PROPOSED REVISED TECHNICAL SPECIFICATIONS

8210050070 820929
PDR ADOCK 05000409
P PDR

WP-1.3

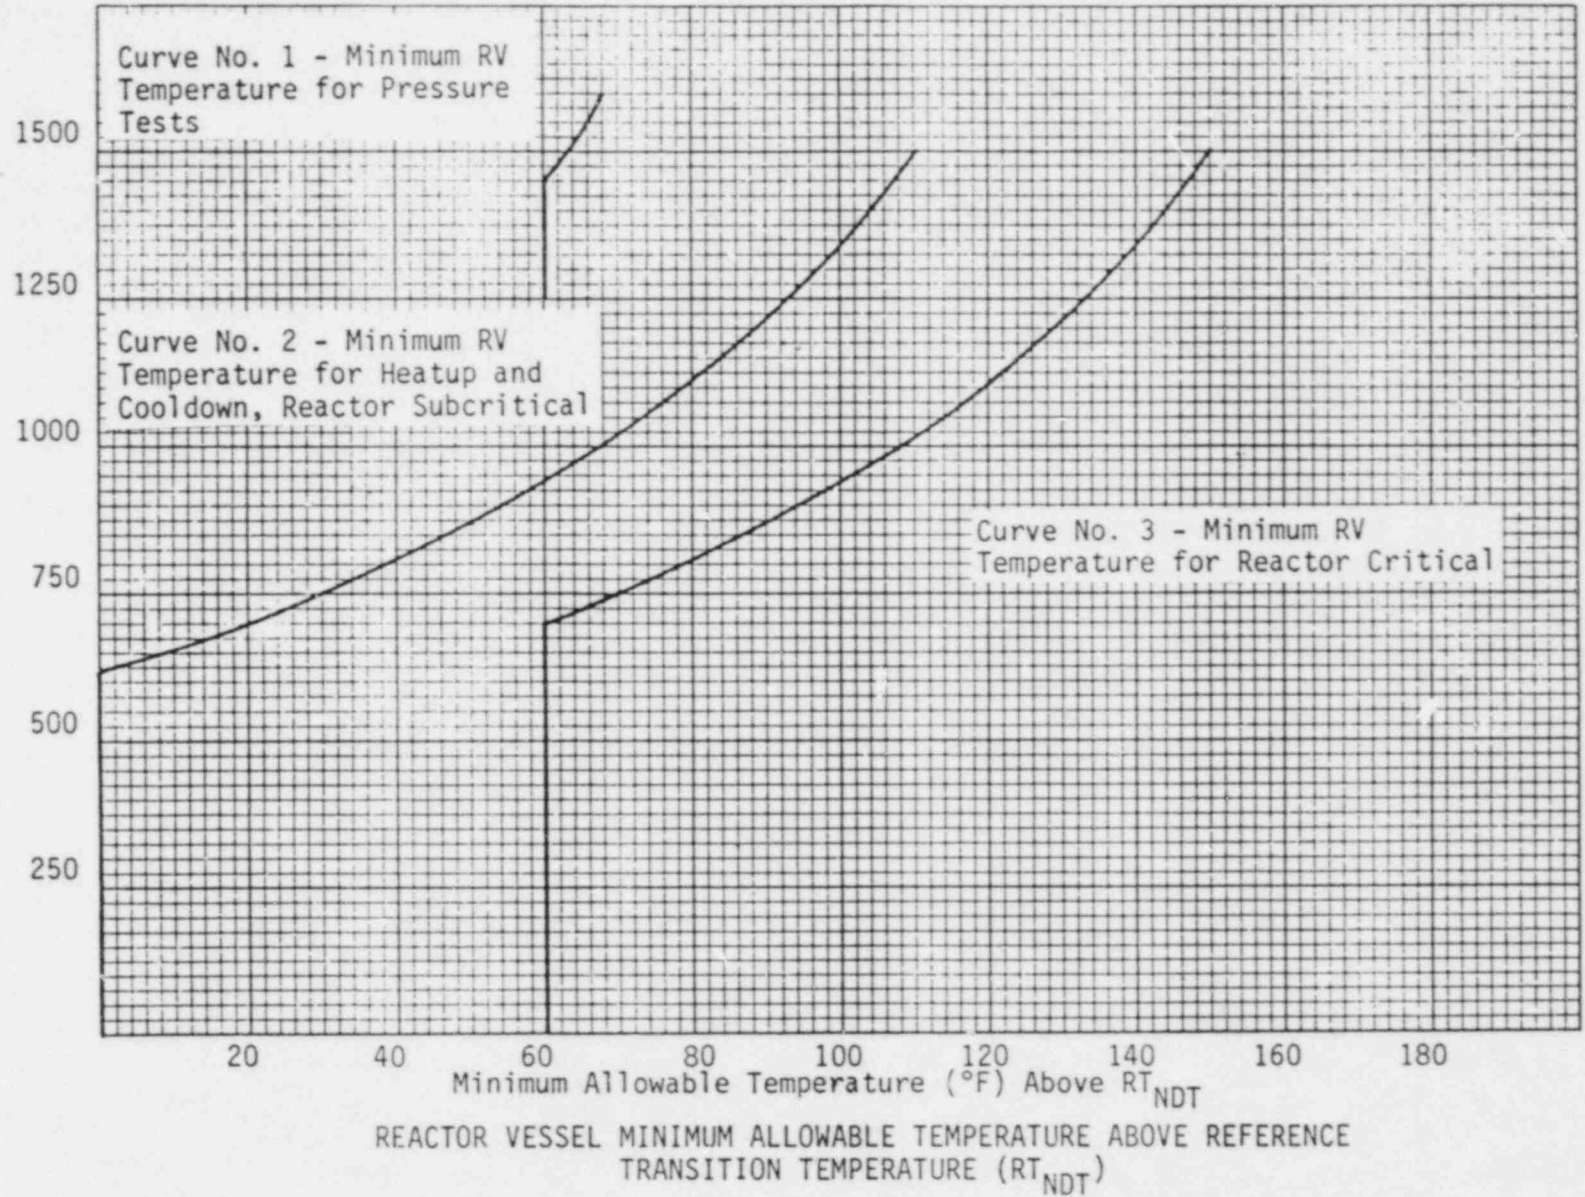
5.2.2.4.1 During system heatup, cooldown, and inservice leak and hydrostatic testing operations, at least once per 60 minutes determine:

- a. The reactor vessel to be within the limits of LCO 4.2.2.4.
- b. The forced circulation loop temperature to be within the limits of LCO 4.2.2.4.

5.2.2.4.2 The reactor material irradiation surveillance specimens shall be removed and examined to determine changes in material properties at the intervals shown in Table 4.2.2.4-1. The results of these examinations shall be used to update Figure 4.2.2.4-2, and as a factor to predict vessel lifetime.

FIGURE 4.2.2.4-1

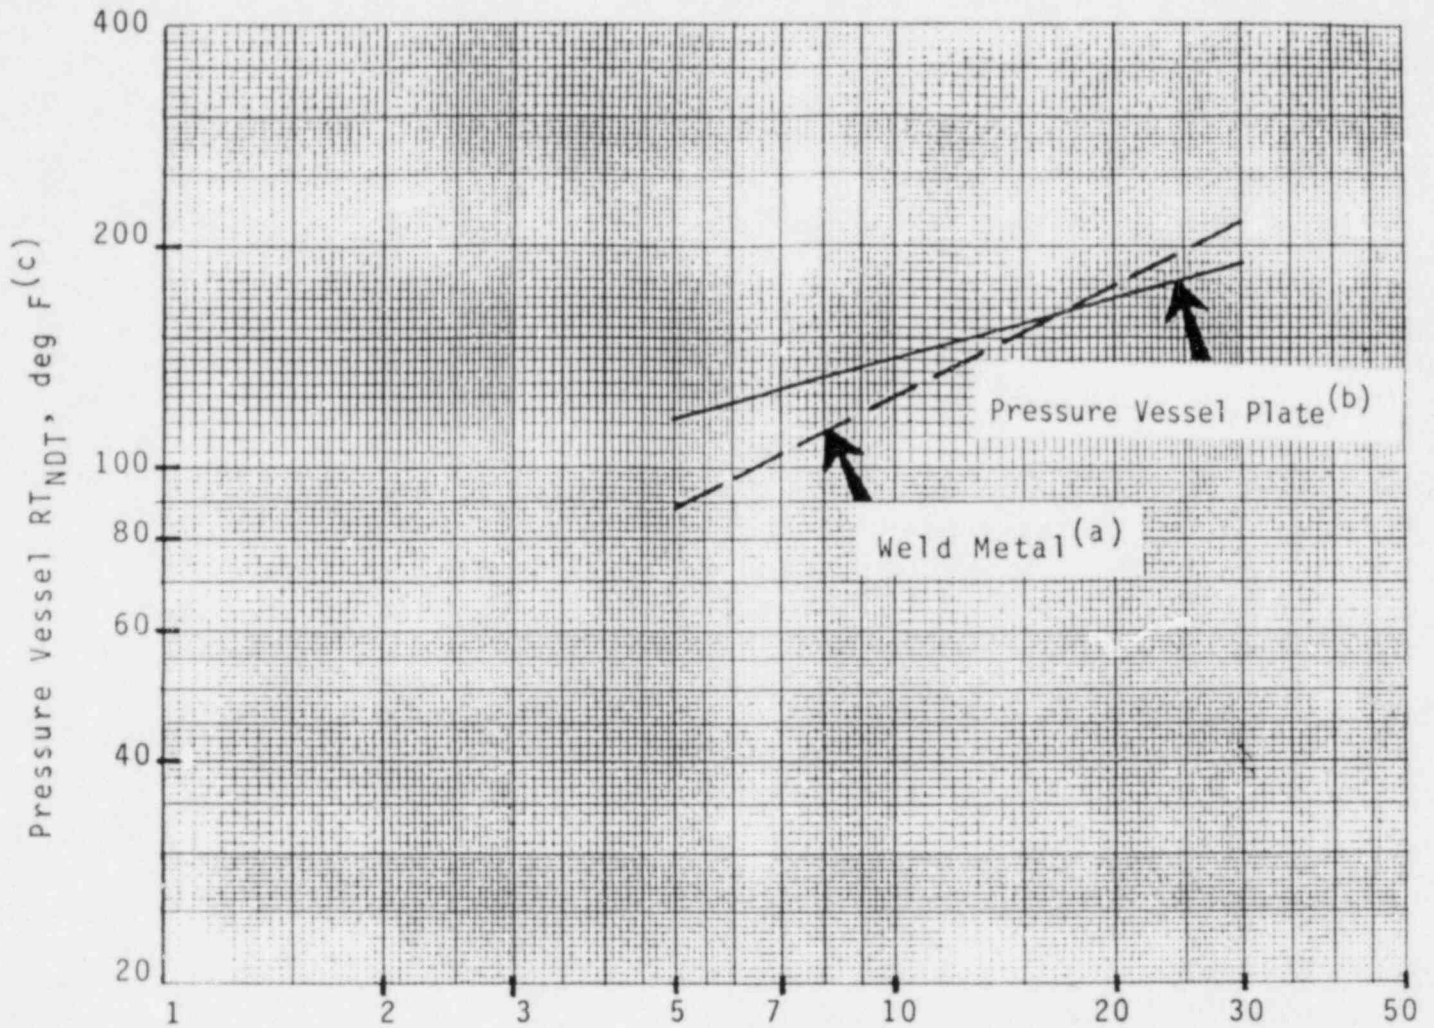
4.2.2.4 The reactor coolant system pressure, measured at a level above the normal operating water level, and temperature above RT_{NDT} shall be limited in accordance with the limit lines shown on Figure 4.2.2.4-1 as Curve No. 1 for inservice hydrostatic or leak testing; Curve No. 2 for heatup and cooldown when the core is subcritical (except when the reactor vessel is vented) and; Curve No. 3 for operation with a critical core (except for low power physics tests or when the reactor vessel is vented) with:

- a. A maximum heatup rate of 100°F per hour of reactor vessel,
- b. A maximum cooldown rate of 150°F per hour of reactor vessel,
- c. A maximum difference between the reactor vessel flange temperature and the closure head flange temperature of 50°F,
- d. The forced circulation loop pressure:
 1. Less than or equal to 280 psig unless forced circulation loop temperature is at least 130°F.
 2. At atmospheric pressure unless loop temperature greater than 70°F.

The heatup and cooldown pressure-temperature limit, Curve #2 on Figure 4.2.2.4-1, is a composite curve. It was prepared by determining the most conservative case, with either the inside or outside wall controlling, for any heatup rate up to 100°F per hour or with the inside wall always controlling where the cooldown thermal gradients tend to produce tensile stresses while producing compressive stresses at the outside wall for any cooldown rate up to 150°F per hour.
